UNITED STATES PATENT AND TRADEMARK OFFICE

10/551,293

Office Action Summary	Application No. 10/551,293	Applicant(s) STEVENS-WRIGHT ET AL.	
	Examiner BENJAMIN LEE	Art Unit 4137

DETAILED ACTION

FIG. 2

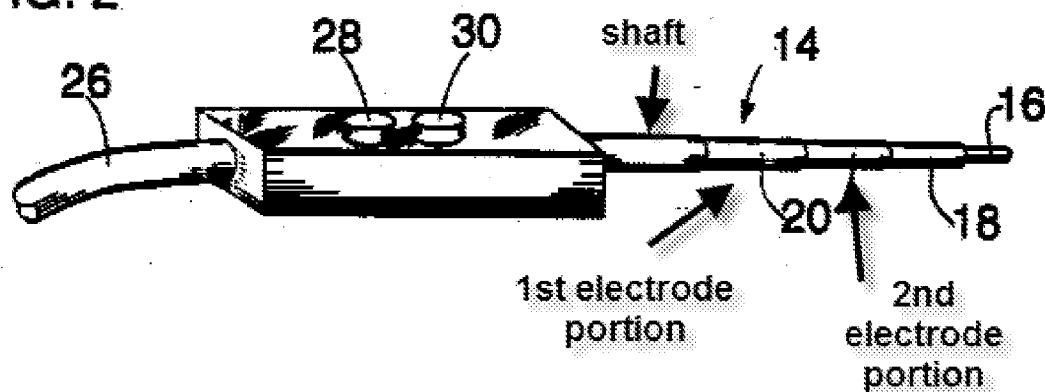
As to claim 1, Goldhaber discloses a catheter (a tubular medical device for insertion into body cavities, according to Merriam-Webster Dictionary) comprising a longitudinal catheter shaft as labeled in Fig. 2 below. The device is for positioning an ablation electrode 14 within a patient's body since the device has a waveform for cutting (col. 1, lines 14-19). The ablation electrode has an outer surface that is as a whole disposed **on** a shaft since its most proximal portion (labeled 1st electrode portion below) rests inside the shaft and sits **on** the inner surface of the shaft (Fig. 2, col. 3, lines 9-12). Furthermore, each tube of ablation electrode 14 has an electrode portion since they are

electrically connected to the operative tip (Fig. 3, lines 9-22). The limitations of claim 1 do not preclude the possibility of an insulation layer over the electrode as seen in Fig. 3. The electrode is convertible from a first configuration in which the electrode outer surface has a first axial size and a first radial size (Fig. 1) to a second configuration in which the electrode outer surface has a second axial size and maintains the first radial size (Fig. 2, col. 3, lines 32-37).

As to claim 2, Goldhaber teaches that the ablation electrode comprises a first electrode portion and a second electrode portion (see Figs. 2-3 below). Again, the limitations of claim 2 do not preclude the possibility of an insulation layer over the electrode portions as seen in Fig. 3. The second electrode portion has a length and is moveable in the axial direction of the catheter (Figs. 1 & 2, col. 3, lines 32-37). In the first configuration, more of the second electrode portion length is contained within the first electrode portion than in the second configuration as inferred from Figs 1 & 2.

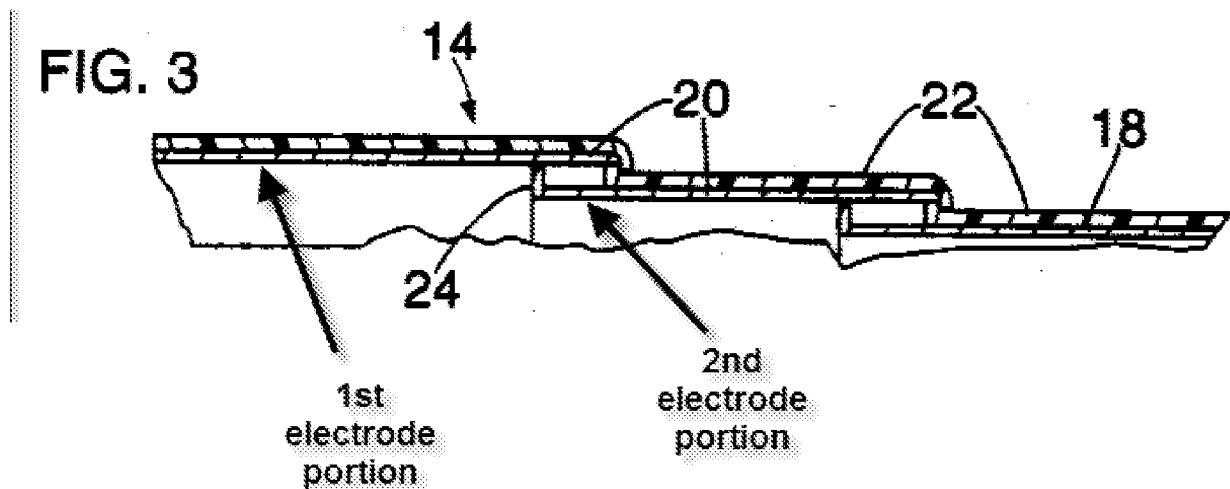
As to claim 4, Goldhaber teaches that the ablation electrode comprises a third electrode portion (18) that is at least partially contained within the second electrode portion in the first configuration, as shown in Fig. 1.

As to claim 6, Goldhaber teaches that the ablation electrode is a ring electrode since the electrode has a ring shape as shown in Figs. 1 & 2.

As to claim 7, Goldhaber teaches that the first electrode portion and the second electrode portion are cylindrical since they are tubular (Figs. 2 & 3, col. 3, lines 9-12).

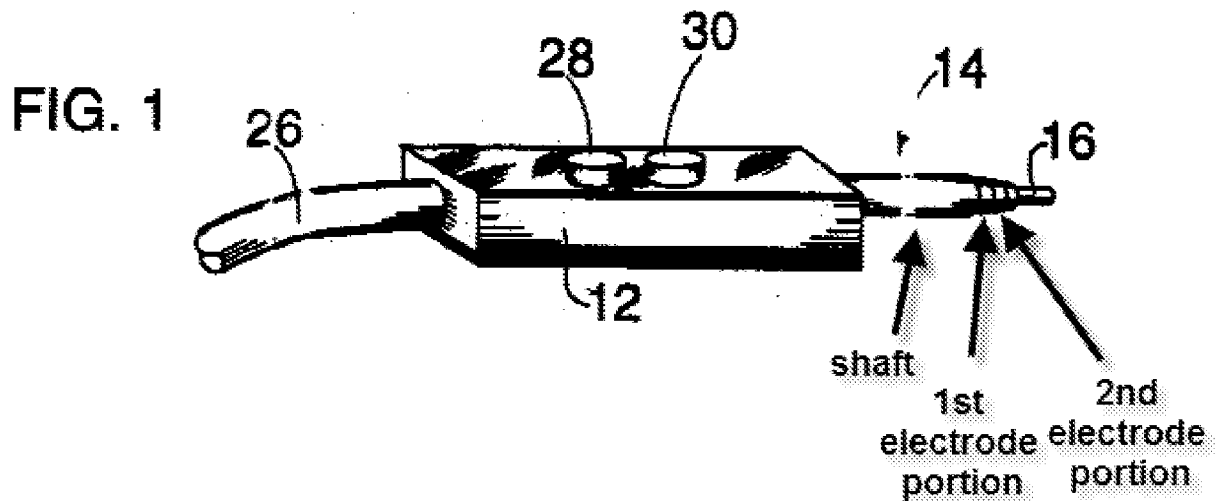
As to claim 16, Goldhaber teaches an ablation electrode 14 for ablating tissue (col. 1, lines 14-19) comprising a first ablation electrode portion configured for mounting on a catheter shaft (see Fig 2 above). The first electrode portion is called a first ablation electrode portion since it is electrically connected to the ablating operative tip 16. The first ablation electrode portion has an outer surface (16) configured to emit electrical energy since it is electrically connected to the supply line carrying the appropriate

waveform (col. 3, lines 19-23). A second ablation electrode portion is configured for mounting on the catheter shaft (see Fig. 2 above) and has a surface configured to emit electrical energy since it is electrically connected to the supply line carrying the appropriate waveform (col. 3, lines 19-23). The second ablation electrode portion is moveable from a first position substantially inside the first ablation electrode portion to a second position substantially outside the first ablation electrode portion as shown in Figs 1 & 2 (col. 3, lines 32-37).

As to claim 17, Goldhaber teaches the ablation electrode has a third ablation electrode portion (18) configured for mounting on the catheter shaft (Fig. 1), the third ablation electrode portion having a surface configured to emit electrical energy since it is electrically connected to the supply line carrying the appropriate waveform (col. 3, lines 19-23). The third ablation electrode portion is moveable from a first position substantially inside the second ablation electrode portion to a second position substantially outside the second ablation electrode portion as shown in Figs 1 & 2 (col. 3, lines 32-37).

As to claim 18, Goldhaber teaches a longitudinal catheter shaft as explained in regards to claim 16 above. The device, including the longitudinal catheter shaft, is for positioning an ablation electrode within a patient's body (col. 3, lines 32-41). The first ablation electrode and the second ablation electrode are mounted on the catheter shaft as seen in Fig. 1 below.
